Recommended Modifications to the NRC White Paper:

Technical and Regulatory Basis: Interim Acceptance Criteria and Guidance for the Reactivity-Initiated Accident (Appendix 4B of NUREG-0800 Standard Review Plan).

Figure 1. Displaced sodium volume at an injected energy of 70 cal/gm as a function of test rod burnup for both MOX and UO₂ rods tested in the CABRI facility.

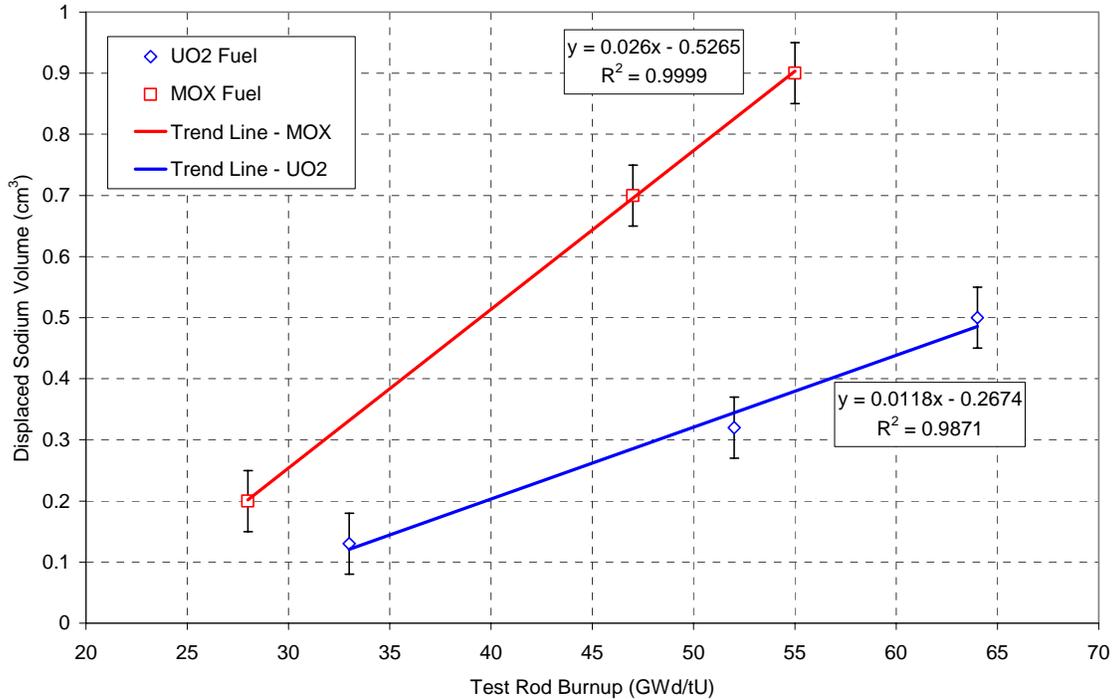
An important indication of the enhanced PCMI due to pellet swelling in the MOX rods comes from the dynamic rod volume changes measured in the CABRI reactor. The effect of MOX pellets on the fuel rod expansion process is shown clearly in Figure 1 which contains a plot of the displaced sodium volume from the flow channel at an injected energy of 70 cal/gm as a function of test rod burnup in the UO₂ and MOX rods tested in CABRI. The amount of sodium displaced from the flow channel is determined by integrating the difference between the channel outlet and inlet flowmeter measurements. The sodium expelled from the flow channel consists of two parts; the prompt part caused by fuel rod volume expansion and the delayed part caused by sodium dilation. The sodium volume displacement from the flow channel that is of interest is that caused by the radial and axial expansion of the test rod during the early energy deposition phase of the RIA tests in CABRI. Early time measurements of the displaced sodium volume represent mostly the fuel rod volume change due to PCMI. In the later portion of the transient, rod to coolant heat conduction causes dilation of the sodium, leading to a further increase in displaced sodium volume beyond that caused by PCMI. The results shown in Figure 1 are at an injected energy of 70 cal/gm, which is early enough in the power pulse for the different tests to minimize the effect of rod to coolant heat conduction on sodium dilation and clearly show the effect of fuel rod expansion due to PCMI.

In general, both UO₂ and MOX fuel rods show a tendency of larger fuel rod expansion with an increase in burnup. Such behavior is caused by the progressively smaller residual pellet-cladding gap from fuel swelling and cladding creep during the base irradiation for the higher burnup rods. More importantly, the measured values shown in Figure 1 demonstrate that the fuel rod volume increases at a faster rate in the highly irradiated MOX rods as compared to the UO₂ rods during the energy deposition phase of the experiments. For the UO₂ rods, the displaced sodium volume results shown in Figure 1 reflect the amount of fuel rod volume change caused by thermal expansion of the UO₂ pellet column. This has been confirmed by analysis. Such is not the case for the MOX rods, where the increase in fuel rod volume is much higher than expected based only on pellet thermal expansion. From the linear trend of the data shown in Figure 1, the effect of burnup on the fuel rod expansion rate is about 2 times higher in MOX fuel than a UO₂ fuel. The larger pellet expansion process in MOX fuel pellets increases the PCMI forces on the cladding, thus increasing cladding deformations in MOX fuel rods. As a result, the failure of CABRI REP Na-7 at a radial average peak fuel enthalpy of 113 cal/gm does not represent a UO₂ fuel rod at the same fuel enthalpy. Based on this assessment, a separate failure threshold is required for MOX fuel that accounts for the increase in PCMI forces as burnup increases.

Figure 2. Definition of time of maximum prompt fuel enthalpy rise

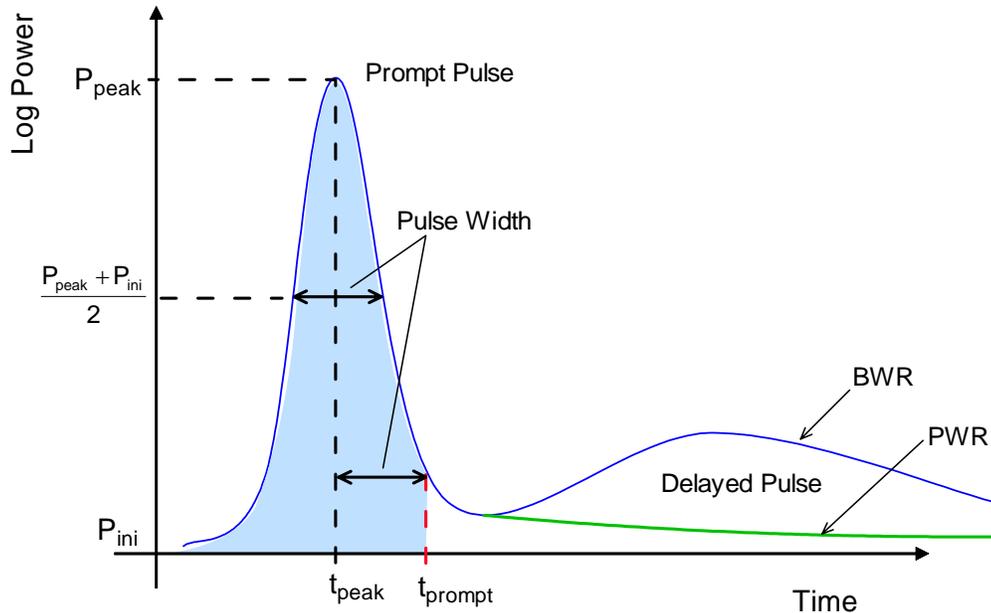
8. It is recommended that the fuel enthalpy rise in failure criterion #2 for PCMI failure shown in Figures 3.1-3 and 3.1-7 be changed to the prompt fuel enthalpy rise and that the use of failure criterion #2 be restricted to the prompt fuel enthalpy rise for both BWRs and PWRs. The prompt fuel enthalpy rise is defined as the radial average fuel enthalpy rise at the time corresponding to one pulse with after the peak of the prompt pulse as shown in Figure 2. Failure criterion #1 for non-PCMI failure should be applied to the total fuel enthalpy (prompt + delayed) to evaluate failure by non-PCMI processes.

Because of the power pulse characteristics of both the BWR control rod drop accident and the PWR control rod ejection accident, the fuel enthalpy rise consists of two parts; (1) the prompt part during which limited clad heating occurs, and (2) the delayed part during which significant clad heating has occurred. The total fuel enthalpy rise is the sum of the two parts. Cladding failure by PCMI is only possible during the prompt part of the power pulse when the pellet thermal expansion rate exceeds the heat conduction rate across the pellet-cladding

gap to the cladding. During the later delayed part of the fuel enthalpy rise, significant clad heating occurs with a corresponding improvement in material ductility, which precludes failure by PCMI. Failure by high temperature processes (ballooning/burst or oxidation embrittlement) is still possible during the delayed fuel enthalpy rise, depending on the maximum cladding temperature and the pressure differential across the cladding. In a commercial LWR, the prompt part of the fuel enthalpy rise is 70% to 90% of the total enthalpy rise. In developing a failure criterion for PCMI, the enthalpy rise to failure from the PCMI-related failures in NSRR and CABRI only applies to the prompt part of the total enthalpy rise.
